International Marina Consultants - Consultants to the Marina Industry

**Re: EDEN SAFE HAROUR PROJECT
EOI – WAVE ATTENUATOR CONTRACT**

As requested we have reviewed the above referenced EOI General Attenuator Location and Alignment as depicted in the EOI Figure 1, especially focusing on the incentive for the maximum marina aspect.

PORT OF EDEN MARINA LAYOUT

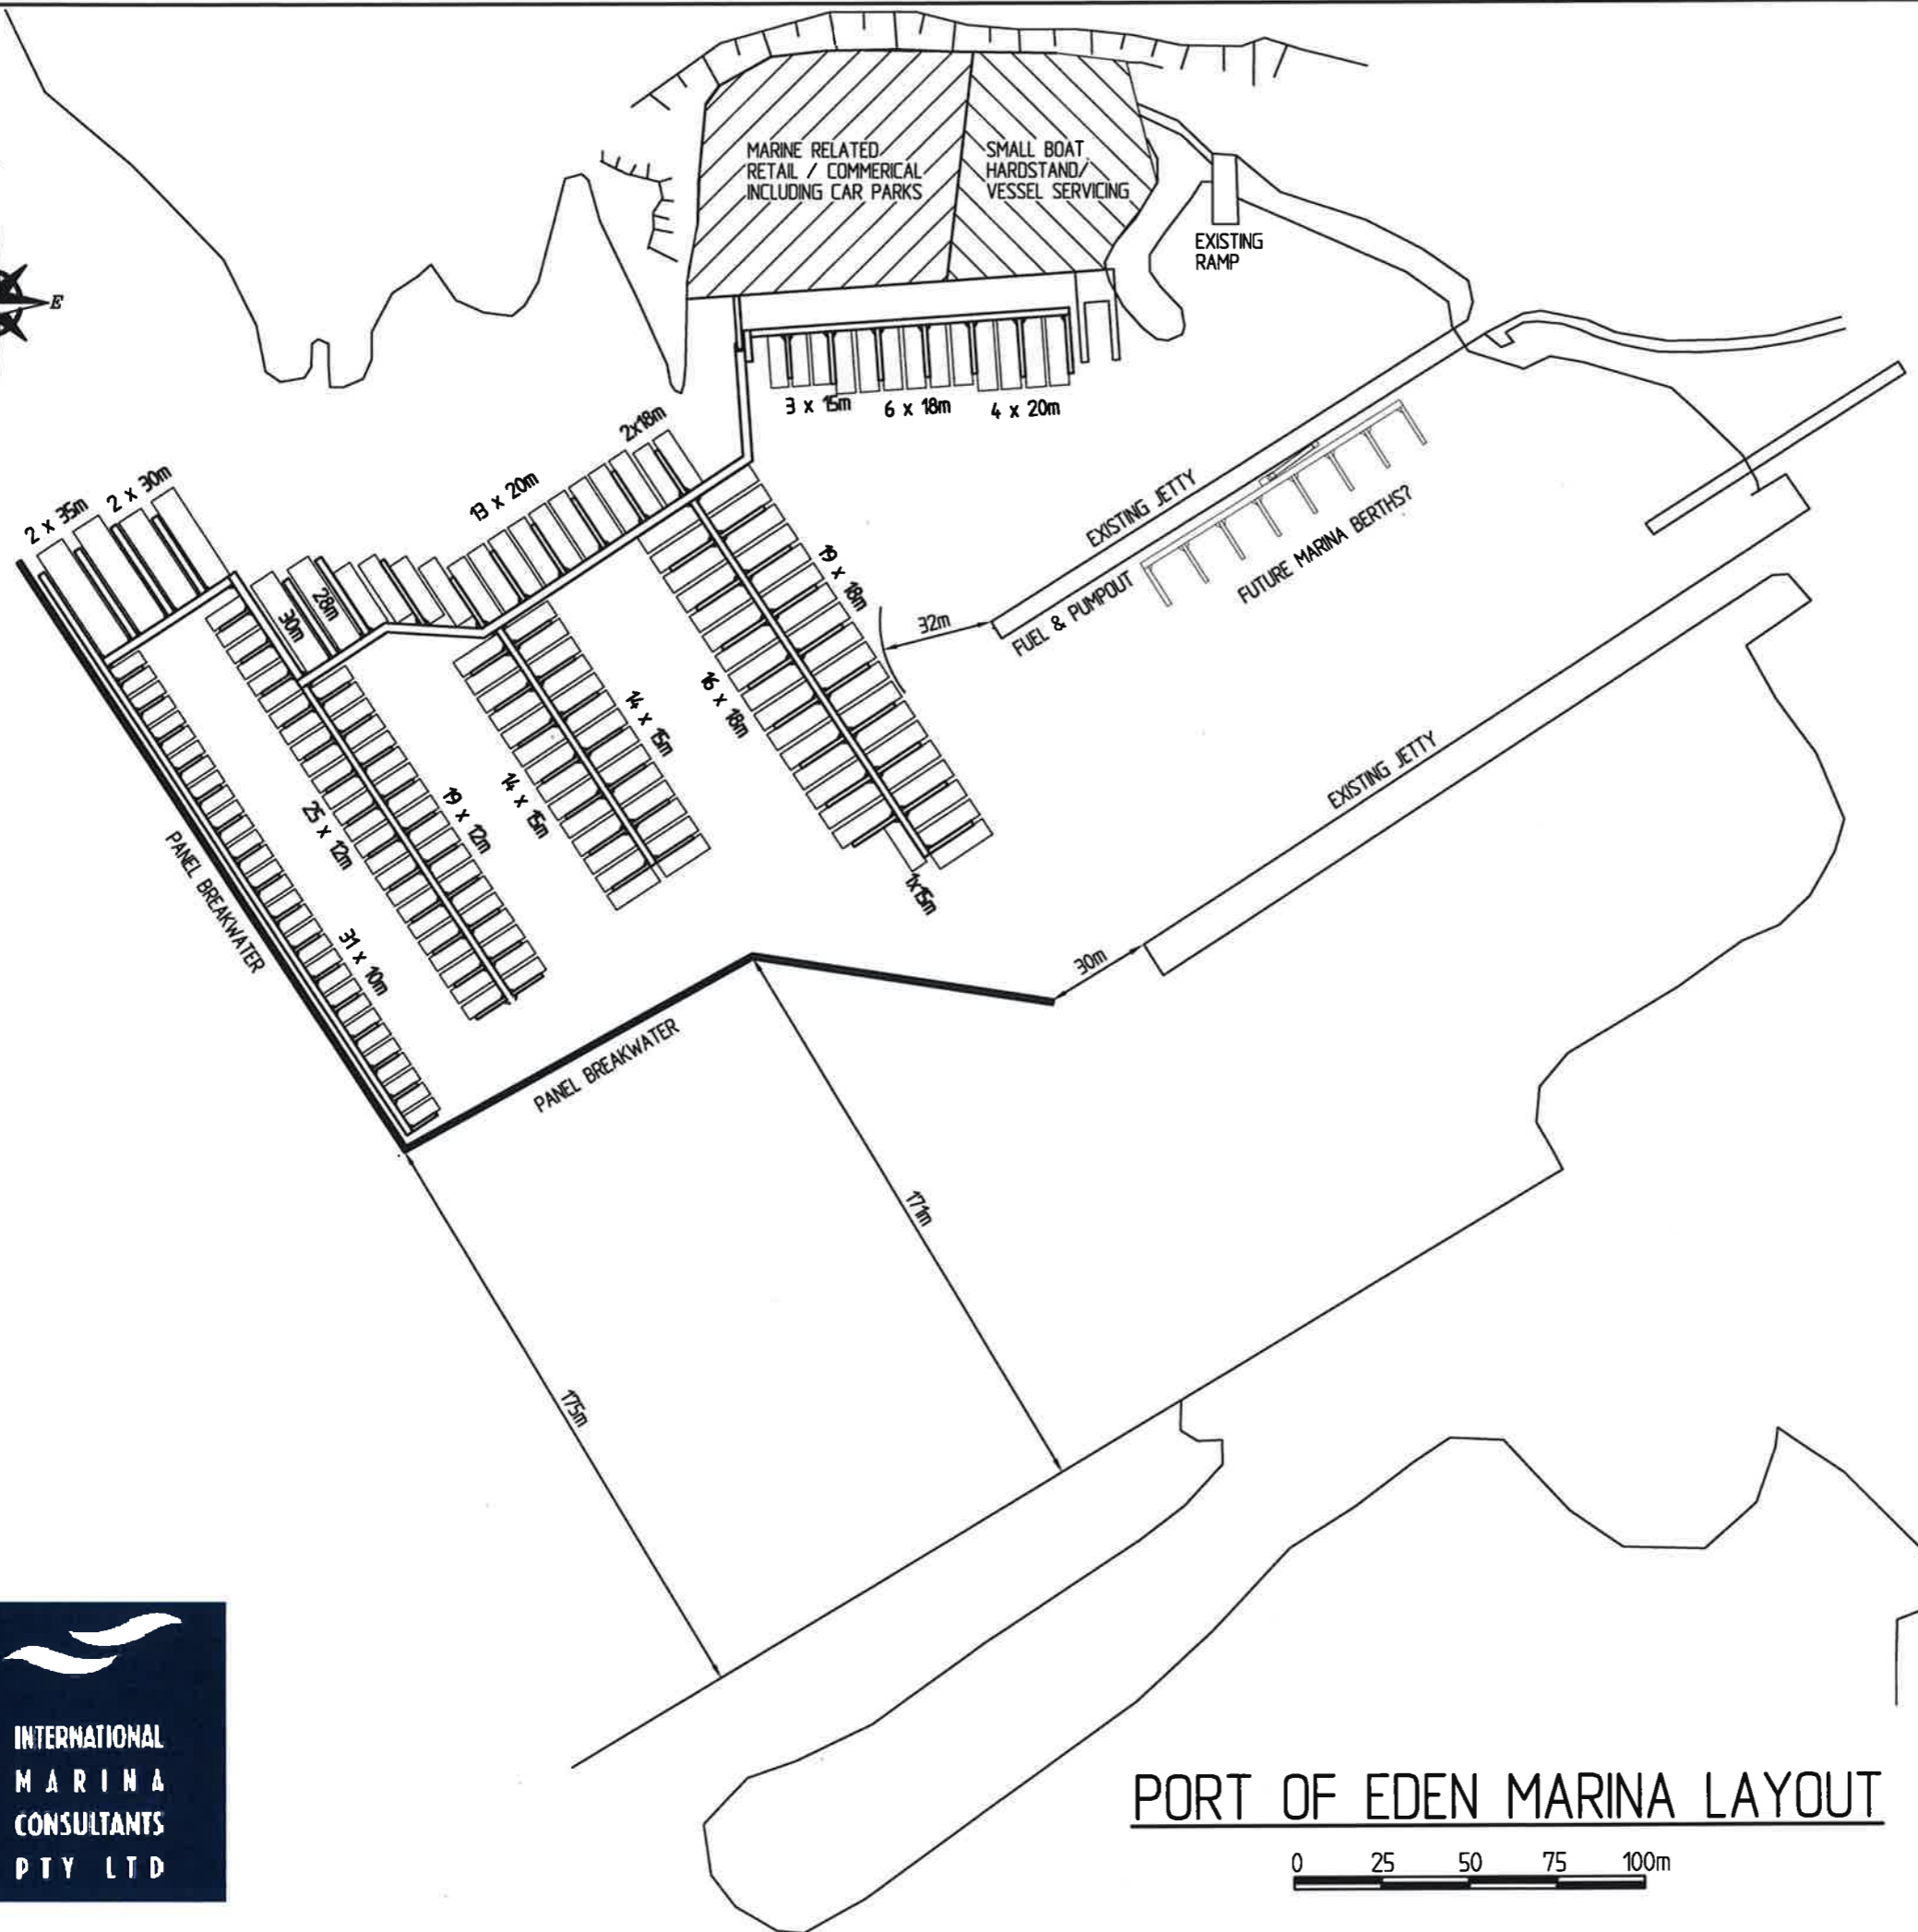
The proposed attenuator alignment would lead to the loss of about 100 berths relative to the 170 berth marina concept (4197-SK7 attached) making the marina non-commercial at 70 berths.

To emphasise this, attached drawing 4197-SK8/A depicts the loss of around 56 berths for such a channel requirement and set back compared to our layout drawing 4197-SK7.

PORT OF EDEN MARINA LAYOUT EOL ATTENUATOR LOCATION WITH INTERNAL CHANNEL & SET BACK LOSSES

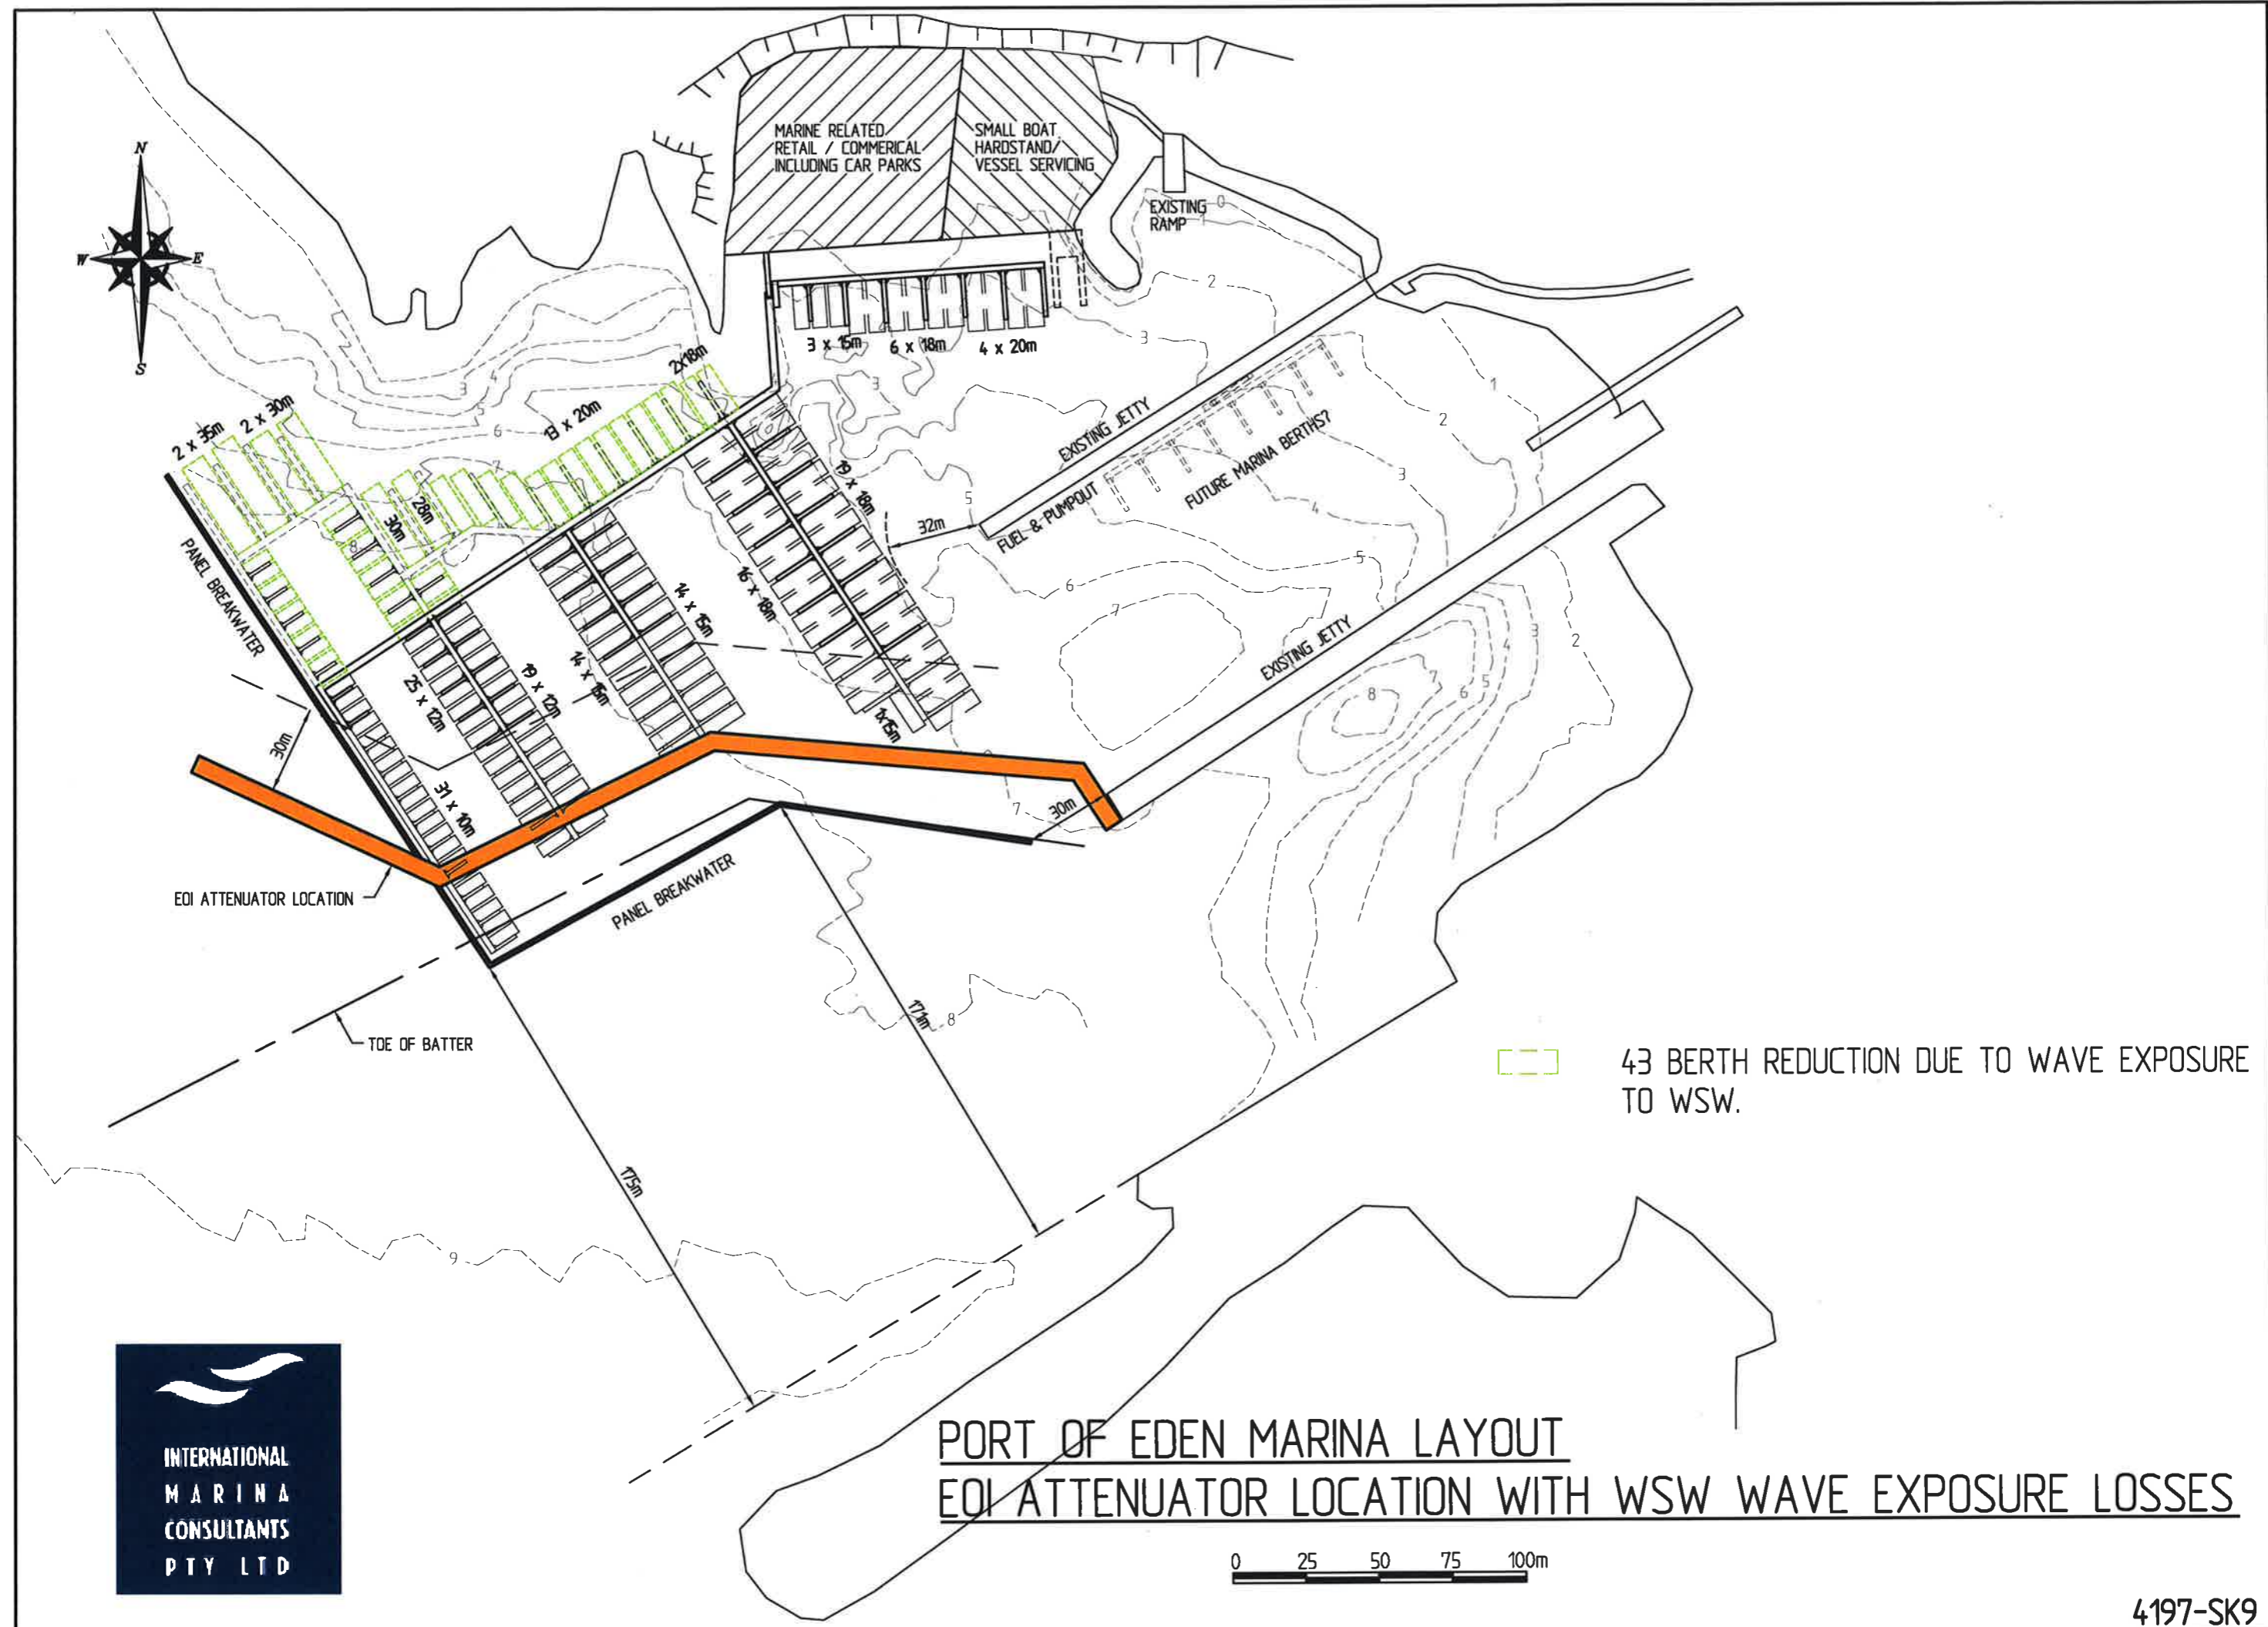
The loss of access between the Multi-Purpose Jetty and the attenuator requires continuous channel access from the western only entrance, to this Jetty.

Also any set back of the attenuator from the required cruise ship berthing area again reduces useable harbour space. It is understood that 160m is required for the cruise ships but the current proposal allows about 190m.

56 BERTH REDUCTION FOR INTERNAL CHANNEL
AND SET BACK
